Project	IEEE 802.16 Broadband Wireless Access Working Group < http://ieee802.org/16 >	
Title	Changes on Sleep Mode SDLs and MSCs	
Date Submitted	2004-01-15	
Source(s)	Chulsik Yoon, Jaeheung Kim, Kunmin Yeo ETRI 161 Gajeong-Dong, Yuseong-Gu, Daejeon, Korea	Voice: +82-42-860-6826 Fax: +82-42-860-6732 mailto: csyoon@etri.re.kr
Re:	This is a response to a Call for Comments IEEE 802.16e-03/58 on IEEE 802.16e-03/07r5	
Abstract	This document contains suggestions to change the SDLs and MSCs reflecting working groups agreements on the Sleep Mode operation.	
Purpose	The document is submitted for review by 802.16e Working Group members.	
Notice	This document has been prepared to assist IEEE 802.16. It is offered as a basis for discussion and is not binding on the contributing individual(s) or organization(s). The material in this document is subject to change in form and content after further study. The contributor(s) reserve(s) the right to add, amend or withdraw material contained herein.

Changes on Sleep Mode SDLs and MSCs

2. Proposed changes on Sleep Mode operation SDLs and MSCs in IEEE 802.16e-03/07r5

Figure D.13 – Sleep Mode – MSS initiated awakening

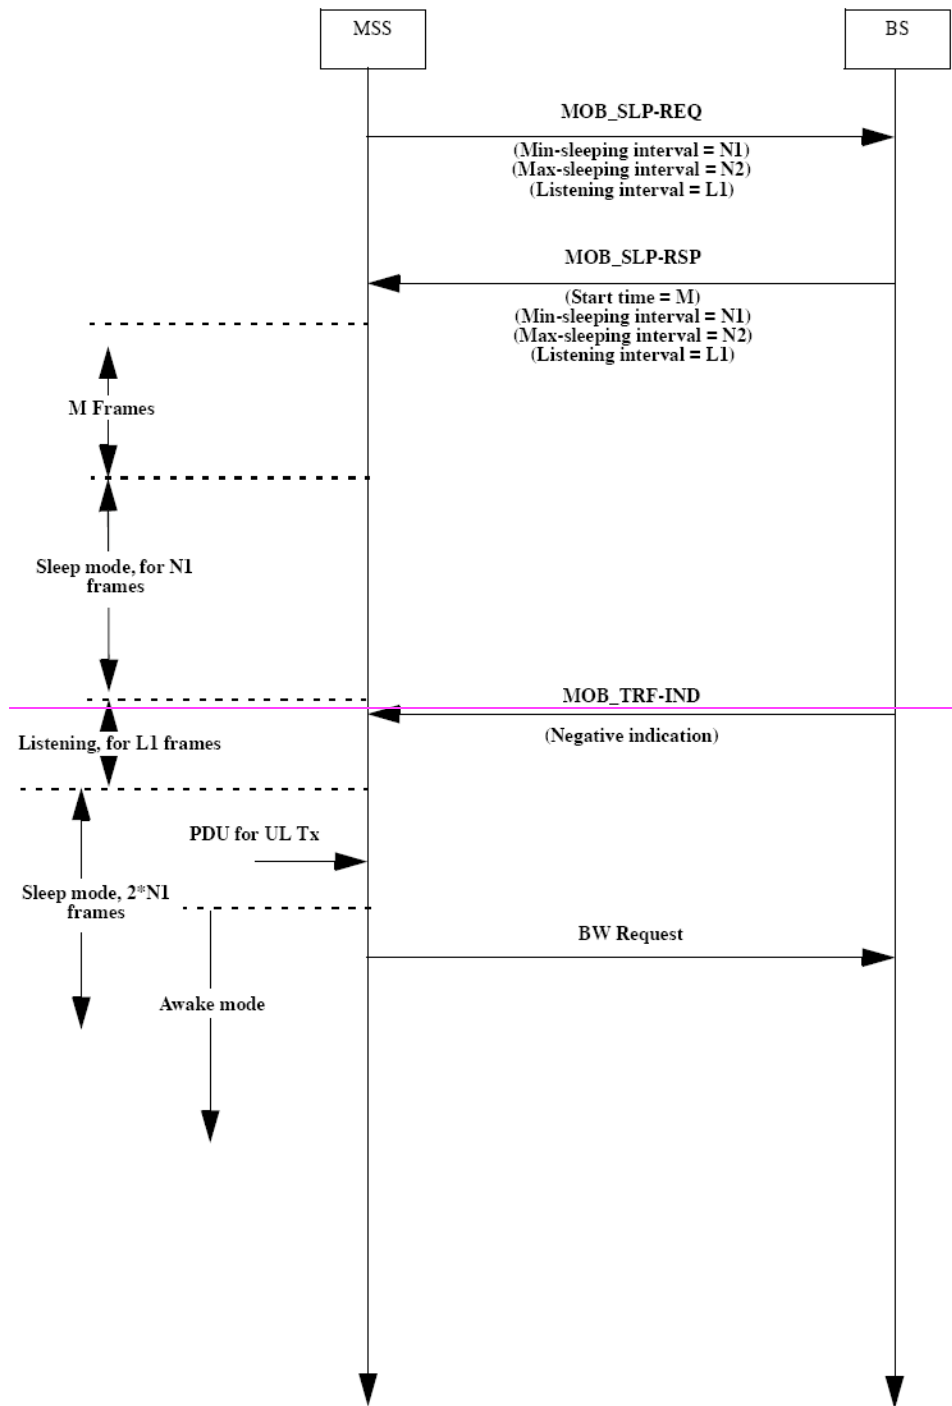
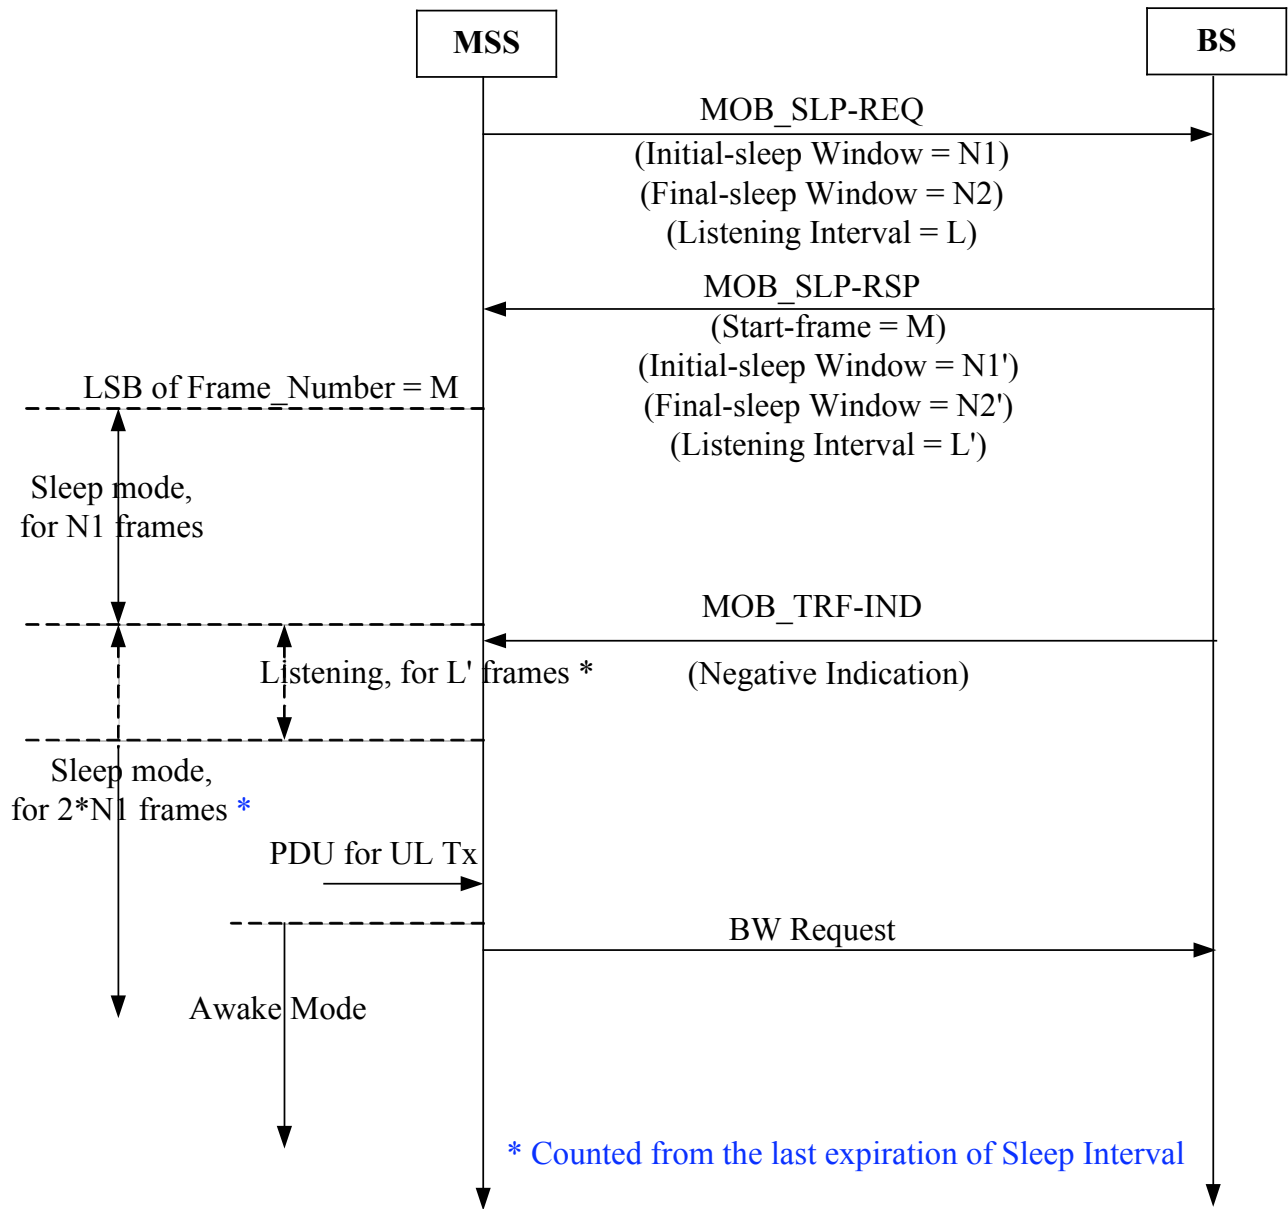
[Replace Annex D.2 Figure D.13 to the following:]
 [From:]
